**LEGAL ADVERTISEMENT
HISTORIC PRESERVATION BOARD
CITY OF PORTLAND
Public comments are taken at all meetings.**

**PUBLIC HEARING
273 CONGRESS STREET**

RE: January 6, 2016 **Public Hearing** – Final Review of Proposed Exterior Alterations

Address: 273 Congress Street (former location of Angela Adams)
India Street Historic District

DEMO ELEVATIONS

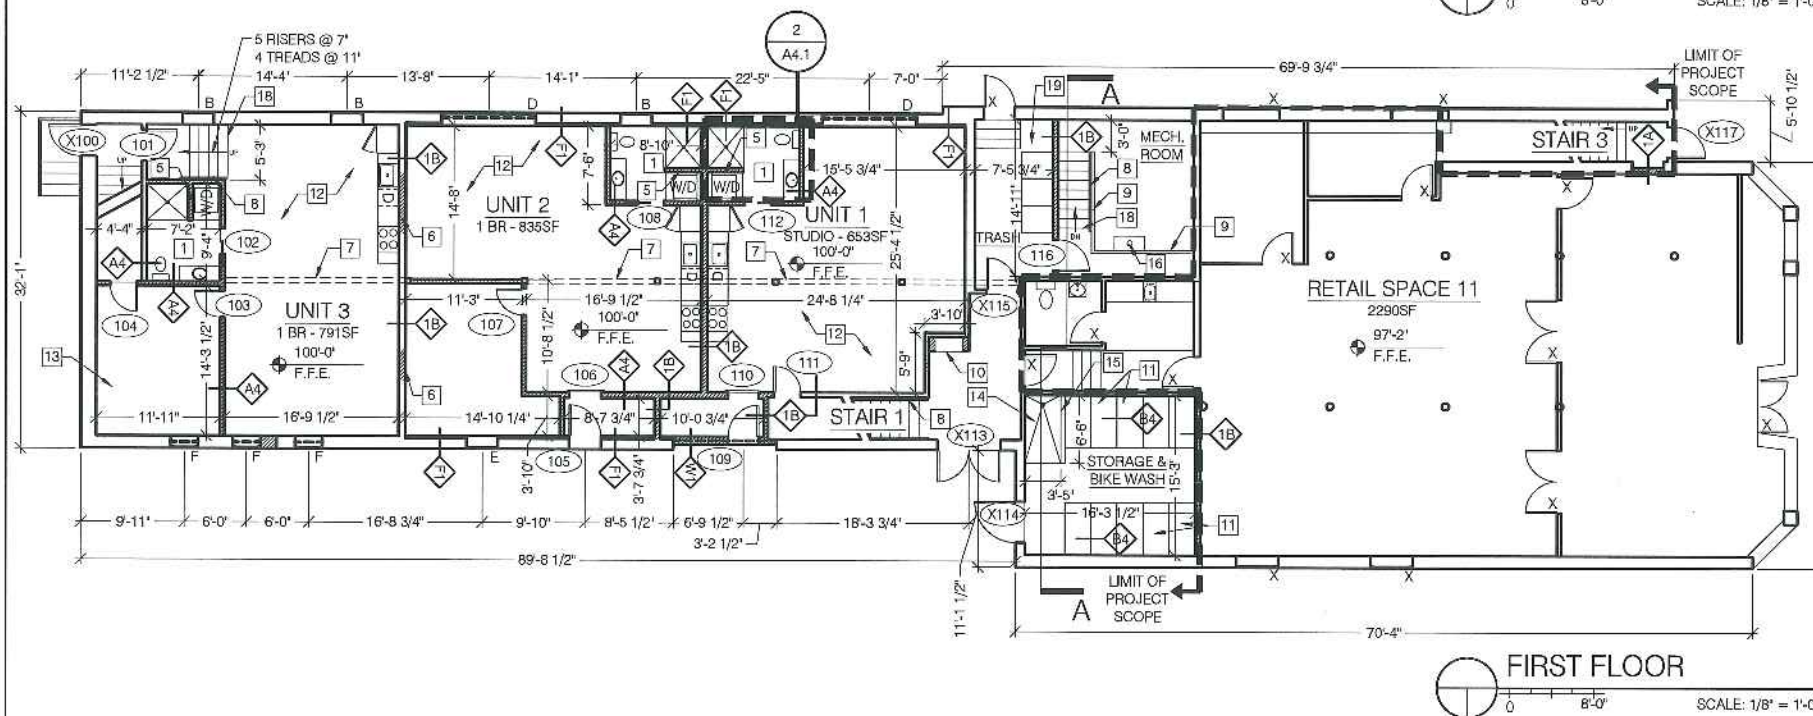
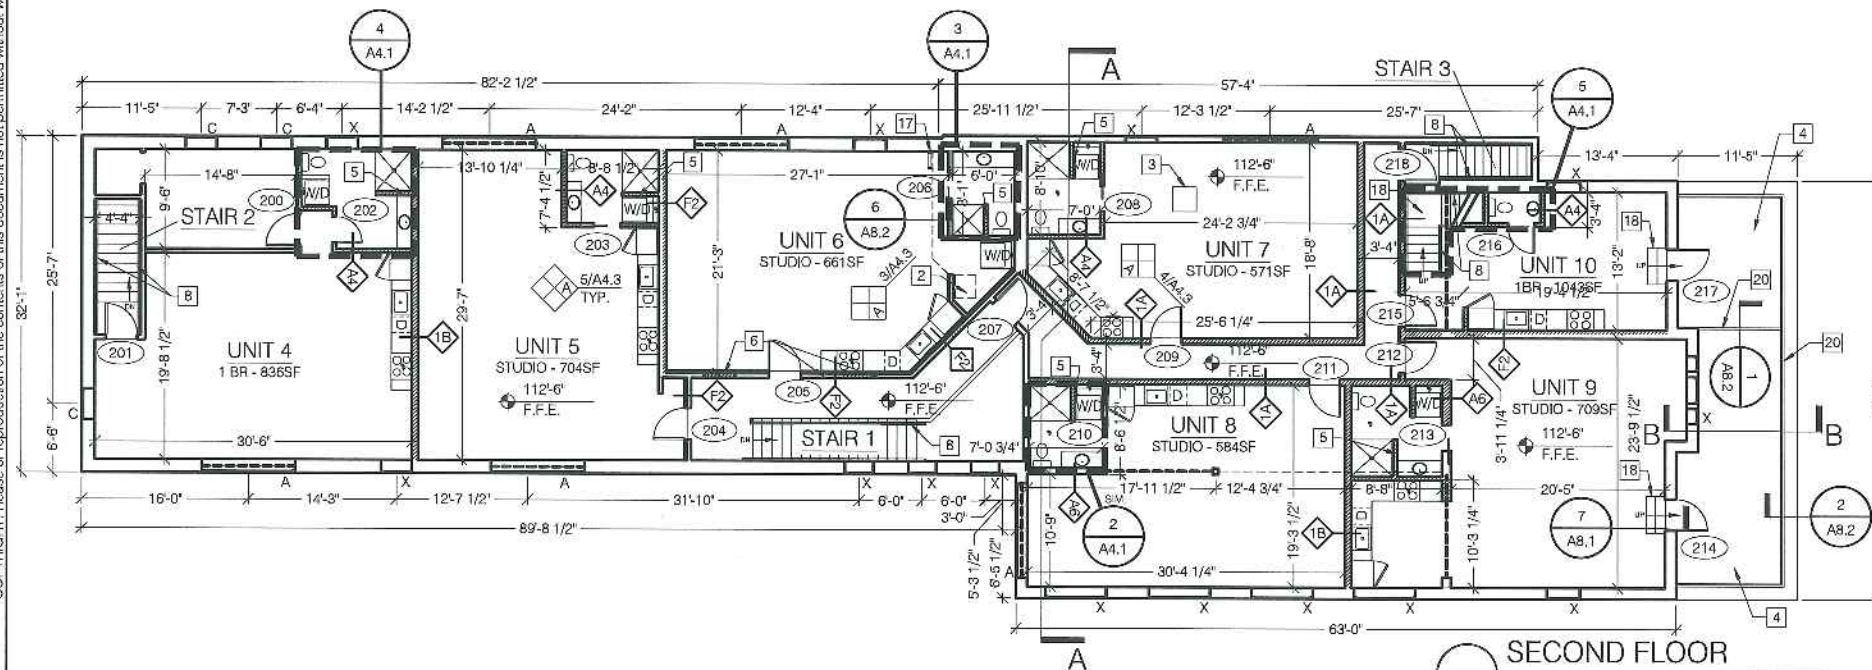
- There was consensus that the obsolete fire escape, unnecessary for life safety, should be removed.
- There was unanimous discomfort with the proposed off-center, solid partition between the two parts of the front rooftop deck.

- Board members suggested that the partition be the same height as the deck railing, despite the compromise of privacy for the two future owners. Centering the dividing rail would be awkward because of the significant, centered window assemblage.

- Most members expressed a desire to see a painted railing in a recessive color, rather than the proposed galvanized rail with a composite wood cap rail.

- While members were comfortable with the replacement of two front windows with doors to provide deck access, some conditions were noted: the full width and height of the masonry opening should be utilized, including the arched top; and details should recall the windows.

In his revisions Mr. Carroll has responded to a number of the Board's concerns about the proposed roof deck and the fire escape. Though the proposed low railing separating the two sections of deck is not centered, it is inconspicuous because it is not solid, and it matches the rest of the railing in design and color. At the time of the workshop, lighting for the deck had not been designed. Though fixtures have yet to be chosen, the architect has followed the Board's recommendation in specifying hidden lighting, mounted to the back of the low parapet and illuminating only the roof deck surface. Perhaps detailed specifications or shop drawings of the access doors that are proposed for the two front window openings should be submitted for a final review, but the intent of the Board appears to have been followed.

Staff notes that the "north" elevation, facing the synagogue, appears to be unchanged from the December 9 submission in any significant way (except for at the front roof deck,) prompting the Board to decide whether they are comfortable enough with the window program as proposed. The window changes proposed for this wall may balance order, coherence and modern style in a way the Board finds appropriate, or the Board may wish to discuss anew the possibility of a more "residential" layout of openings, scale, and window styles. A detail sheet is included in the plans, showing relationships between windows and wall coverings.

- REMOVE EXISTING FIRE ESCAPE. PATCH BRICKWORK AND CLADDING FOR A COMPLETE AND CLEAN REMOVAL.

EXTERIOR MATERIALS

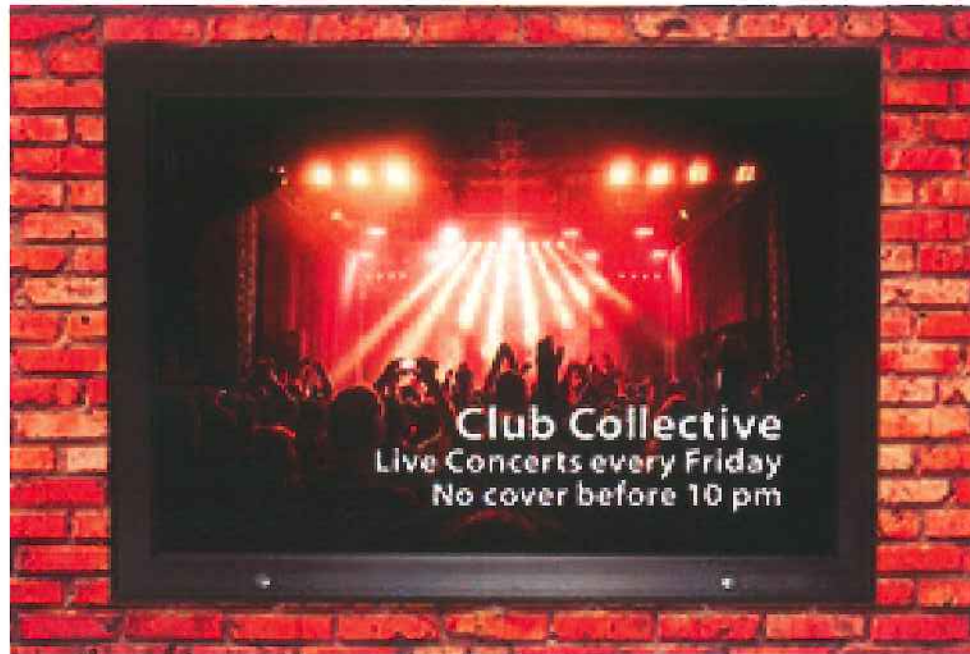
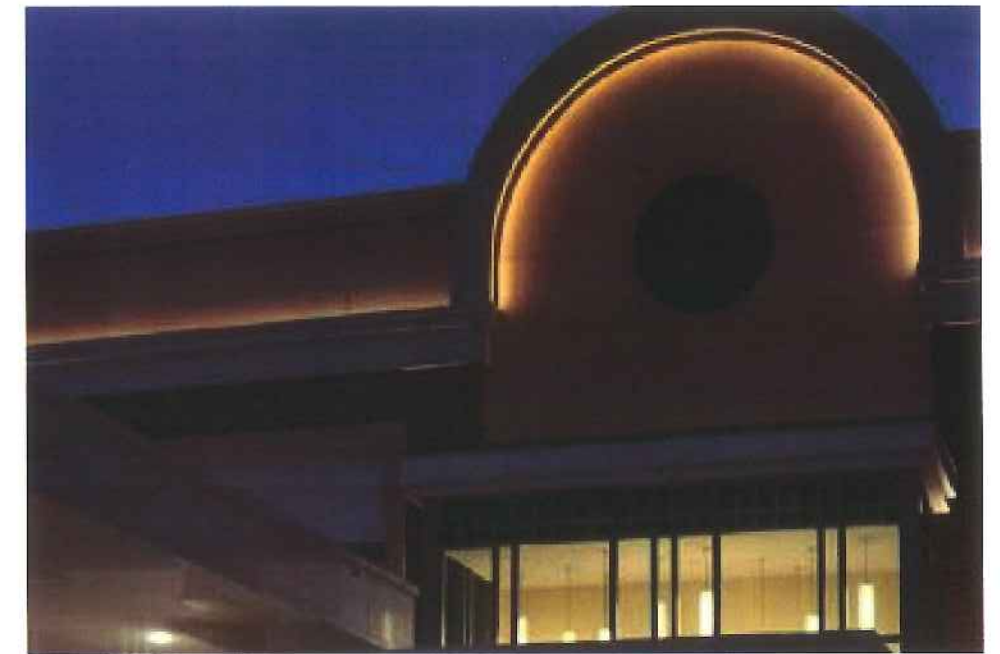
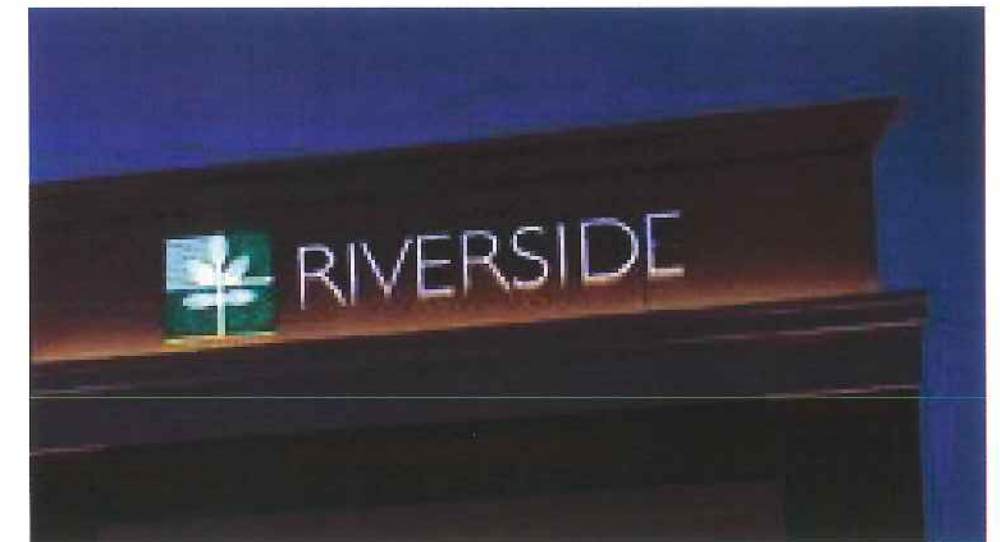
In reviewing the latest plans, staff encourages Board members to give careful consideration to the proposed signage/lighting proposal. Note that plans call for three internally illuminated

building signs, three internally illuminated event display boxes located next to the entrances on Center Street, architectural strip lighting on the upper and lower building walls facing Center street and LED tape lighting under the canopies and upper cornice. It appears from the plans that the under-canopy and cornice tape lighting is intended to change colors. In addition to these exterior lighting elements, a video projection is proposed for a section of the 2nd and 3rd floor windows on Free Street. Given the number and variety of elements proposed, it is appropriate to consider the cumulative effect of the proposed signage and lighting scheme and its compatibility with the surrounding context. While the renovated building can certainly support a contemporary sign/lighting solution and the building will likely benefit from further animation, the overall impact of the numerous elements warrants careful review, as any approval may set a precedent for future applications. Also, with respect to the internally illuminated display boxes proposed adjacent to the Center Street entrances, staff notes that this is the first time this type of display fixture has been proposed in a historic district. Board members are encouraged to inquire about the visual character of the displays, the intervals at which the displays will change, etc. and decide whether this type of fixture is appropriate in this downtown context.

BUILDING ELEVATION - FREE STREET

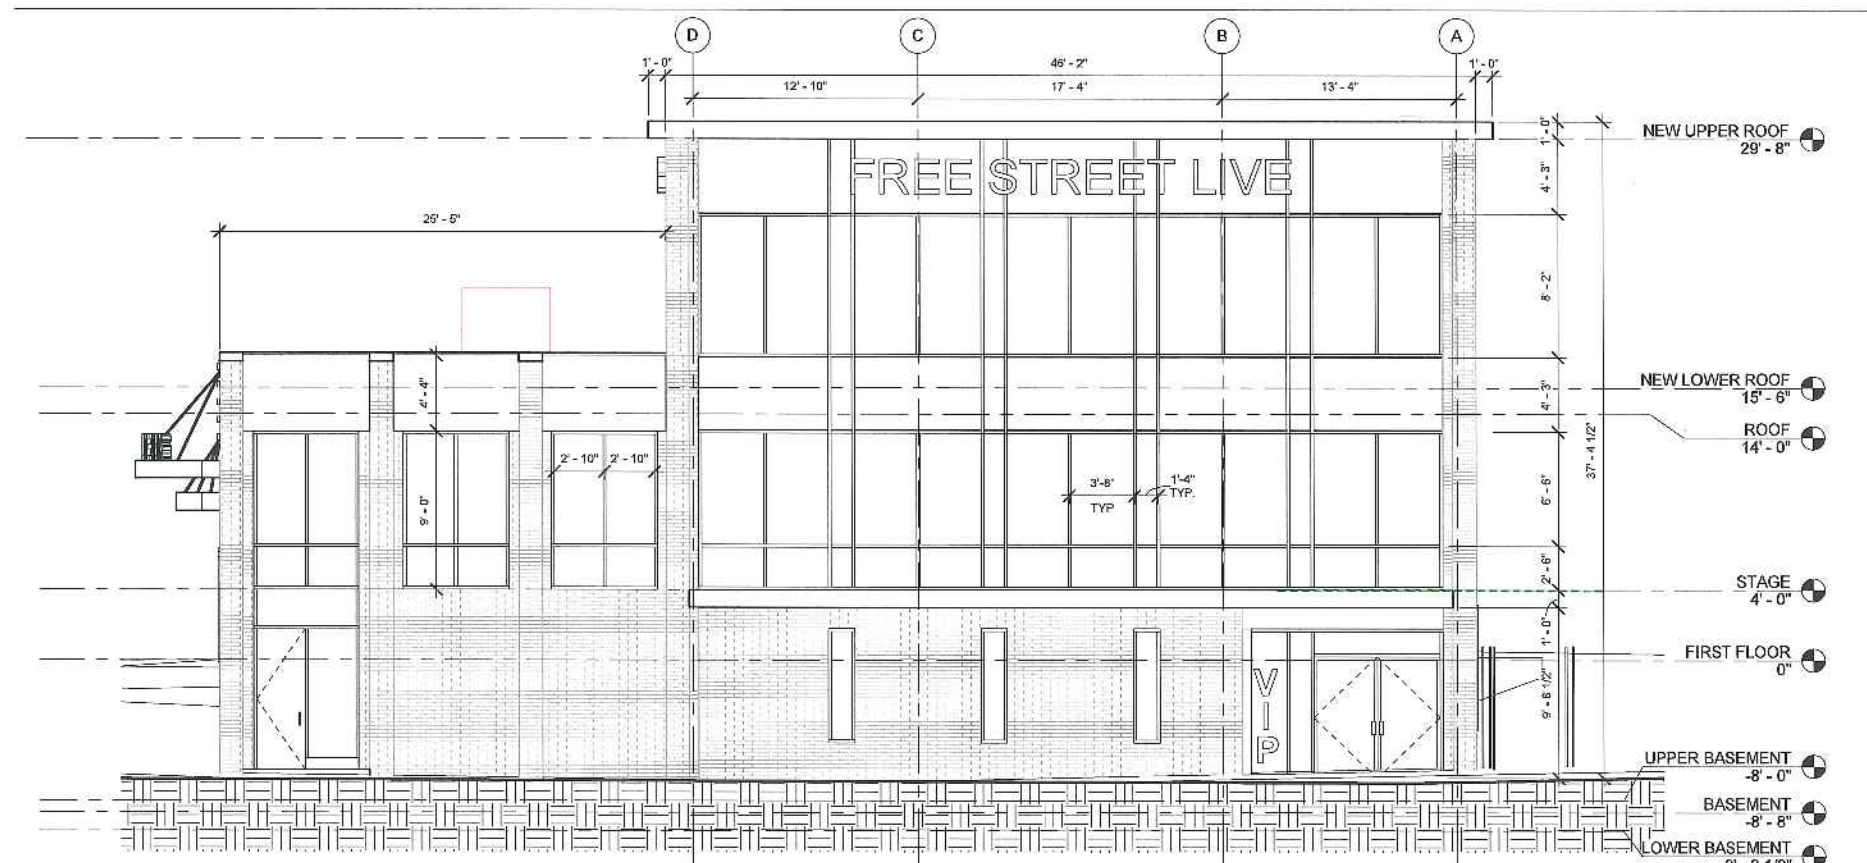
- Entrance at east end of Free Street facade
To provide more visual interest at pedestrian level on Free Street, Board members recommended that this entranceway be widened and given more visual prominence. Given interior constraints, it was understood that the expansion would likely be minimal.

In staff's view, a couple aspects of the new design appear unresolved. First is the presence of vertical panels or "accent medallions" along the ground floor of the Free Street façade. While staff understands that these are intended to continue the pattern of projecting brick piers to the west and to pick up on the window mullions above, their relationship to these elements is not clear or convincing. Also, staff suggests that further consideration be given to the added window on the north elevation. As depicted, it does not appear to be sufficiently integrated with the rest of the design and calls attention to the previous infill.
